PUBLISHED BY FORD MOTOR COMPANY OF CANADA, LIMITED, FORD, ONTARIO, CANADA

JUNE, 1925

Vol. 7

Fig. 1

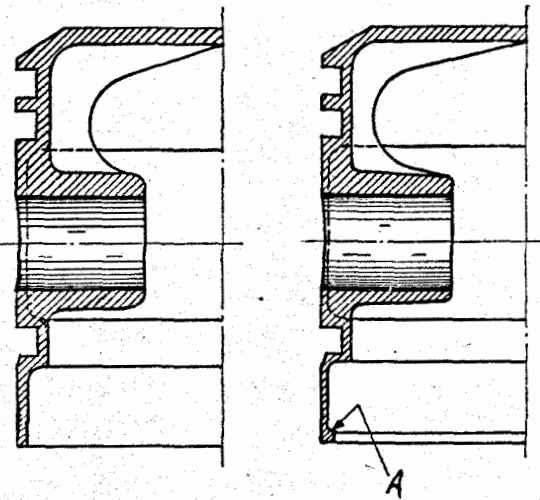
A new design piston has been adopted for use in both production and service which is known as the Light Design Piston. The new piston differs from the old type by having thinner side walls and smaller bosses and holes for piston pin bushings, and can readily be distinguished from the old type by the small flange that extends around the inside edge of the piston, at the bottom of the skirt. See "A", Fig. 1. The change in design reduces the weight of the new type piston to approximately 1 lb. 12 oz.

When replacing pistons it is very important that the correct type piston be used. Persons performing their own overhaul work should be advised to bring in the old piston so that the dealer's stock man may see that they get the proper type piston to replace the one removed. If however, four new pistons are required for the same job the new design piston should be supplied.

Fig. 2

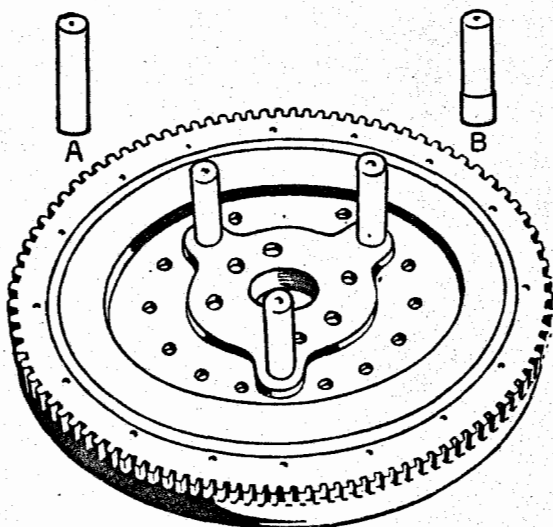
When necessary to remove transmission triple gear shafts, the original shafts (see "A", Fig. 2) should not be replaced in the flywheel, but new shafts, part 3315, should be used, these shafts being .003" larger on the part that

fits into the flywheel, (see "B") than the original shafts.

If the shafts which were removed are again installed in the flywheel it will result in a loose fit, as the holes in the cast iron flywheel become slightly enlarged when the steel shafts are withdrawn, and it is for this reason that 3315 shafts, which as stated above are .003" over-size on the part that fits into the flywheel, must be used for replacement purposes.

Fig. 3

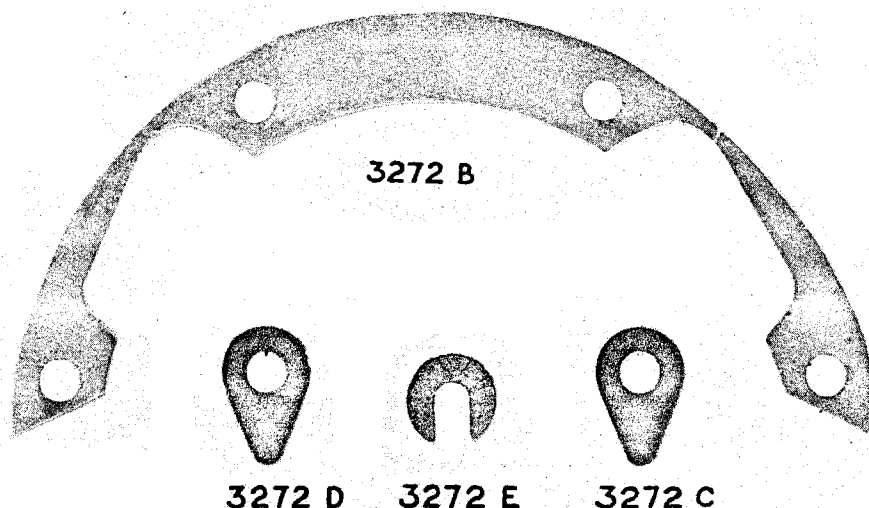
Magneto Coil Support Shim, part No. 3272 has been obsolete and we are now using four types of Shims—parts Nos. 3272-B, 3272-C, 3272-D and 3272-E.

No. 3272-B is a paper shim .007 to .008 inches thick—two of these shims are specified per car and sometimes it is only necessary to use one, while again it may be necessary to use more than two, in order that the gap between the Coils and the Magnets may be set to exactly $\frac{1}{32}$ ".

Occasionally, also, there is a slight variation of the width of the gap between the Magneto Coil and Magnets, i. e., the gap will be greater at one side of the Coil Support than it is at the other. It is to regulate this variation and make the gap uniform at all points that No. 3272-C and 3272-D Shims are used. These Shims are made of steel and are .015 and .025 inches thick respectively.

No. 3272-C is a small thin "U" shaped paper Shim, see E, Fig. 3, which is used for the same purpose as the 3272-C and 3272-D Shims, when it is necessary to obtain extremely close adjustments in getting the gap at exactly $\frac{1}{32}$ of an inch.

Fig. 4

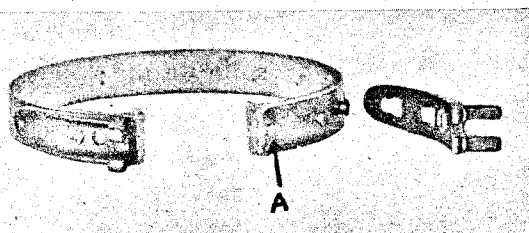
The new design Transmission Band Assembly with the detachable ear (see Fig. 4) has been adopted to simplify the operation of changing Bands. In making this change, the slow speed shaft No. 3427 is shorted, leaving only about $\frac{7}{8}$ " projecting past the slow speed notch No. 3428. This shaft was shorted to make it possible to install the new Band and is sufficiently long to support one end of the Spring No. 3425. The other end of the Spring is supported by a new design Transmission Band Adjusting Screw No. 3419. This new Adjusting Screw instead of being hollow on the inside end, has the end turned down projecting $\frac{3}{4}$ " into the Spring.

To remove detachable ear, start with the reverse Band: place Screw Driver in square hole A, Fig. 4, pry up and back. This unlocks the ear, after which it may be easily removed. Pull the Band out and work the other two Bands forward on the reverse Drum, one at a time, and remove them in a similar manner.

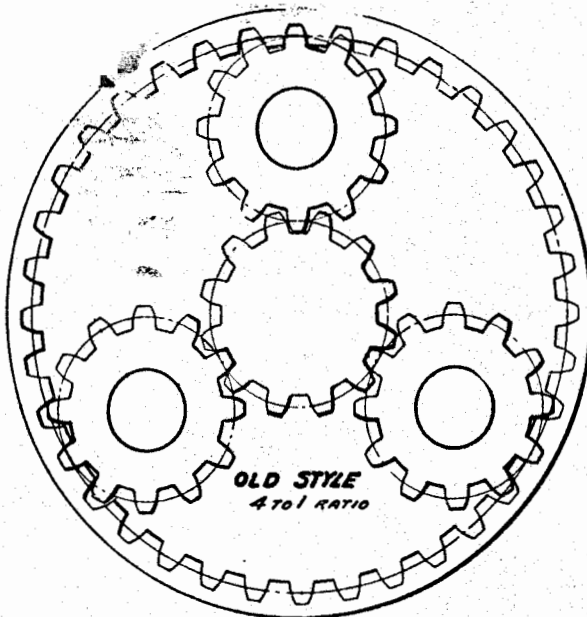
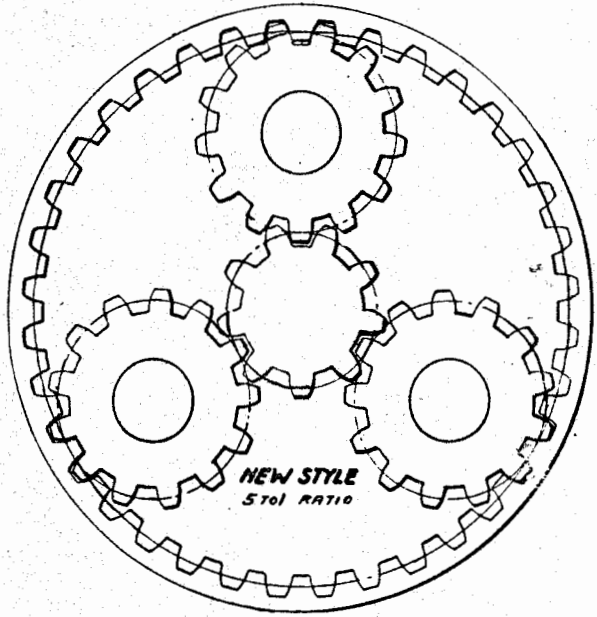
We have recently changed the gear ratio in the steering gear from 4 to 1 to 5 to 1. This has been accomplished by a new design steering gear Pinion No. 3517, having 13 teeth instead of 12, as in the old design, and by a new design steering gear Drive Pinion No. 3519, having 9 teeth instead of 12, as in the old type.

formerly equipped with old gear ratio by replacing the old style steering post with the new design post and a new Pinion, Figures 9 and 10 illustrate the old and new gears.

Fig. 11

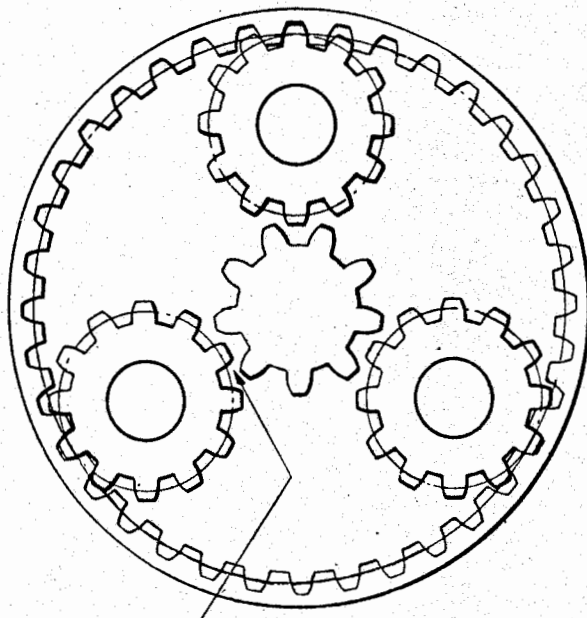
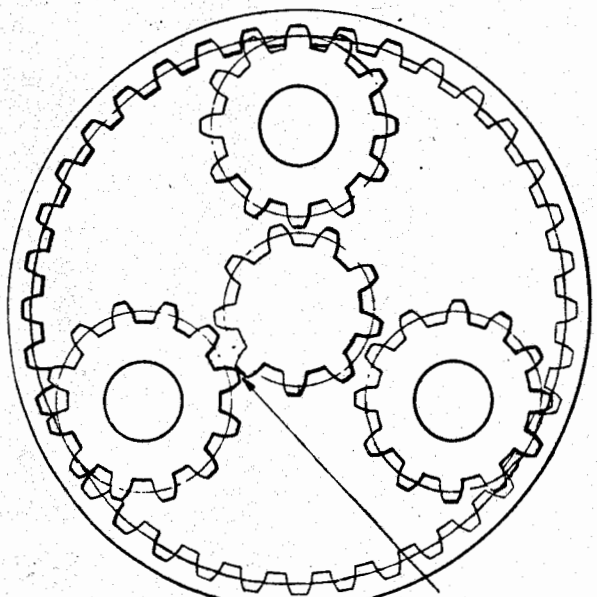
It is very important that you do not attempt to install a new design steering gear drive pinion in an assembly having the old design steering post and gears, as shown in Fig. 11, as the gears will not mesh properly, causing the steering to lock, as shown in Fig. 12.

Incorrect Assembly. Old style planetary cars in relation to new style steering gear driving pinion—DANGEROUS

Locked Gears—result of incorrect assembly—DANGEROUS

Fig. 13

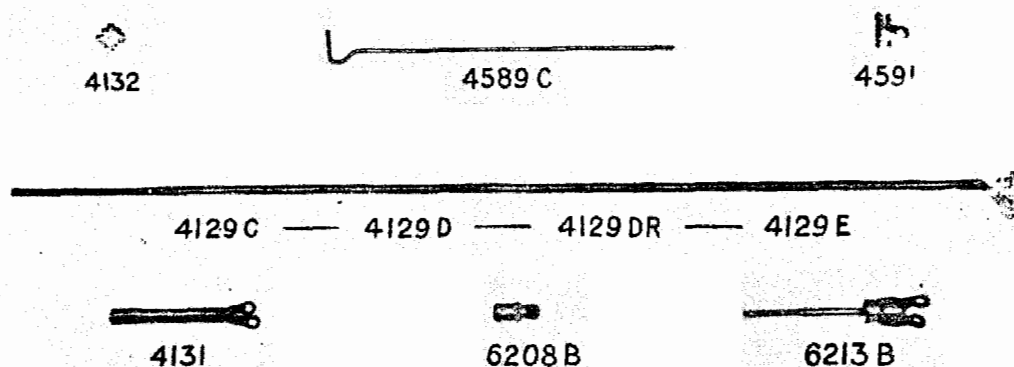
The design of the Carburetor has also been changed slightly. However, this will not interfere in any way with adapting the new style

Spray Needle Assembly No. 6213-B, as the Adjusting Needle Clamp Nut No. 6208-B may be used with the old design Carburetor, see Fig. 13 for illustration of the parts mentioned.

Fig. 14

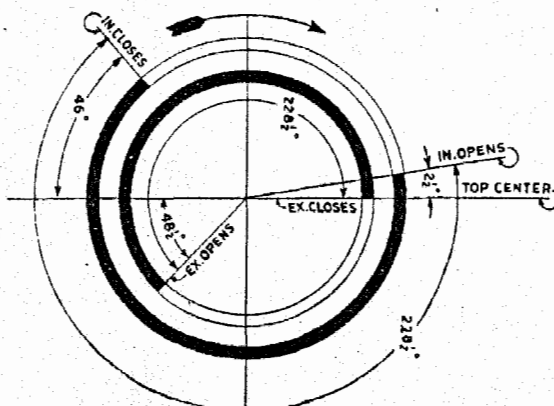
Cars which have the new style camshaft have no change in valve timing as some mechanics have been led to believe by the change in the valve setting marks on the clutch ring. The change in the position of these markings is caused entirely by the change in the contour of the cam.

All Lincoln engines built to date have had the same valve timing as illustrated in Fig. 14.
